Entergy Nuclear Operations, Inc.
(Indian Point Nuclear Generating Units 2 and 3)

PRE-FILED SUPPLEMENTAL REPLY WRITTEN TESTIMONY OF

Dr. RICHARD T. LAHEY, JR.

REGARDING CONSOLIDATED CONTENTION NYS-26B/RK-TC-1B

Figure 1: Comparison of Limit Line (LL) and Best Estimate (BE) predictions, with embrittlement (BE_e) and without embrittlement (BE_{ne}).

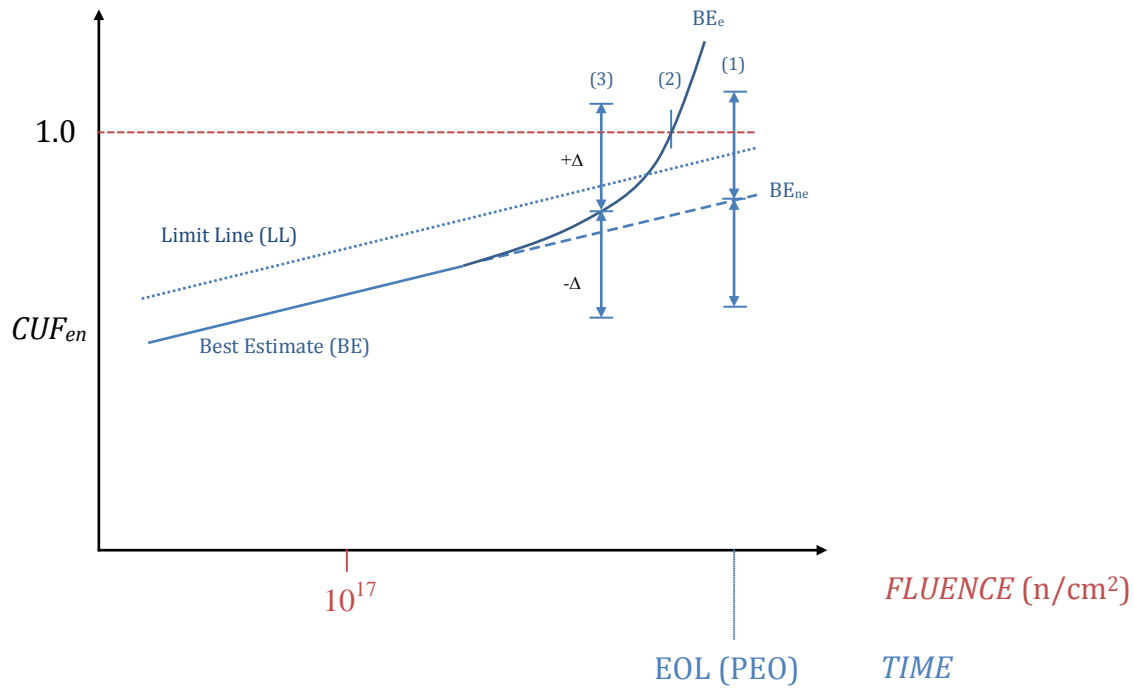
- (1) BE_{ne} predicts possible failure at end of life (EOL).
- (2) BE_e predicts failure (CUF_{en} = 1.0) before end of life.
- (3) BE_e predicts possible failure well before end of life.

2 A. I prepared this Figure to visually illustrate some of
 3 the concerns that I have set forth in my testimony in this
 4 proceeding. Specifically, this Figure shows three important
 5 things: (1) a typical WESTEMS™ "Limit Line" prediction, (2) a
 6 "Best Estimate" prediction of CUF_{en}, the cumulative usage factor
 7 under reactor operating conditions, and the associated

1 uncertainty interval (Δ), and, (3) how the neutron fluence-
2 induced embrittlement of a RVI structure, component, or fitting
3 can dramatically increase the possibility of a fatigue failure,
4 as represented by the cumulative usage factor under PWR
5 operating conditions, CUF_{en} , being equal to unity. This figure
6 applies to RVI structures, components, and fittings made of
7 stainless steel or other materials. In summary, in Figure-1, I
8 have illustrated two different approaches for calculating a
9 time-dependent CUF_{en} , namely the "Limit Line" and the "Best
10 Estimate" calculation. For the "Best Estimate" line, I also
11 illustrate typical uncertainty intervals, delta (Δ), and the
12 effects of fatigue on embrittled (e) and on non-embrittled (ne)
13 RVIs.

17 [REDACTED]
18 [REDACTED] The "Limit Line" shown in Figure-1 includes
19 Entergy's implicit assumption that a stainless steel RVI
20 structure, component, or fitting remains perfectly ductile, and
21 thus shows that the CUF_{en} for a RVI will increase with an
22 increasing number of fatigue cycles, but that it is not affected
23 by the fluence. The "Limit Line", therefore, uniformly

1 increases in CUF_{en} even after the fluence exceeds 10^{17} n/cm²,
2 where significant embrittlement begins to develop (i.e., it is
3 assumed that the number of cycles to failure are not a function
4 of fluence). Figure-1 shows that, as the RVI component
5 approaches the end of life (EOL) for the period of extended
6 operation (PEO), [REDACTED] "Limit Line" will approach
7 (but still be below) $CUF_{en} = 1.0$. This is depicted as location
8 (1).

11 A. Not necessarily. As shown in Figure-1, a "Best
12 Estimate" prediction plus the uncertainty (Δ) may predict
13 possible RVI structure, components or fitting failures (i.e.,
14 $CUF_{en} = 1.0$), sooner than the "Limit Line" would. Moreover, the
15 effect of embrittlement can make the situation much worse. The
16 problem is that no one knows how much conservatism, if any, is
17 in the [REDACTED] "Limit Line". As a consequence, we can have no
18 confidence that "Limit Line" results near $CUF_{en} = 1.0$, are
19 sufficiently conservative to bound all the possible
20 uncertainties, as illustrated in Figure-1 by Δ .

3 A. Yes, the plot depicts two "Best Estimate" predictions
4 for a hypothetical RVI component: one under conditions of no
5 embrittlement (BE_{ne}), for which the "Best Estimate" CUF_{en} line
6 continues to increase as the fatigue-inducing cycles (N)
7 accumulate with time, and the other "Best Estimate" prediction
8 (BE_e) which includes the effect of embrittlement on the (now
9 time-dependent) maximum allowable cycles (N_f). For the latter
10 case, increases in fluence result in more embrittlement and thus
11 a more rapid increase in CUF_{en} than in the former case. This is
12 because after a fluence of about 10^{17} n/cm², significant
13 irradiation-induced damage and embrittlement begin to occur.
14 Embrittlement results in the loss of fracture toughness and the
15 loss of ductility. Even though the data taken to date have been
16 inconclusive, there is ample evidence that this embrittlement
17 may reduce the number of fatigue cycles to failure (N_f) and thus

20 A. Location (1) shows that, even if embrittlement is not
21 considered, RVI fatigue failure may occur by the end of life for
22 the period of extended operation. This is because the sum of a

1 "Best Estimate" prediction plus the uncertainty interval (Δ)
2 associated with this prediction would exceed $CUF_{en} = 1.0$. In this
3 case the "Limit Line" result is clearly non-conservative.

6 A. Location (2) shows that embrittlement can result in
7 the physical failure of the RVI well before the end of life for
8 the period of extended operation.

11 A. At location (3), the "Best Estimate" plus uncertainty
12 (Δ) for the case considering embrittlement (BE_e) predicts
13 possible failure of the hypothetical RVI component well before
14 the end of life for the period of extended operation, even
15 though the "Limit Line" prediction indicates substantial margin
16 to failure at this point. That is, at location (3) the CUF_{en} for
17 the "Best Estimate" line, accounting for embrittlement and for
18 all uncertainties (i.e., $BE_e + \Delta$), exceeds unity. Moreover, as I
19 have stated in my previous testimony, highly embrittled RVIs may
20 fail even sooner than by fatigue alone if significant seismic or
21 shock loads occur. That is, fatigue-weakened and embrittled
22 structures cannot tolerate large impulsive seismic and shock
23 loads like fully ductile structures can. Moreover, other

1 synergistic aging effects, such as the thermal embrittlement (TE)
2 of some CASS RVIs (the upper part of the core support columns)
3 would may move the BE_e curve to the left of its position shown in
4 Figure-1 (i.e., the RVI would be predicted to reach failure,
5 $CUF_{en} = 1.0$, even sooner than the cases (2) and (3) in Figure-1).

8 A. Yes. Because of Entergy's failure to explicitly
9 account for uncertainties, and for the effect of embrittlement
10 on fatigued RVIs, we can have no confidence in the "Limit Line"
11 type of CUF_{en} predictions [REDACTED]
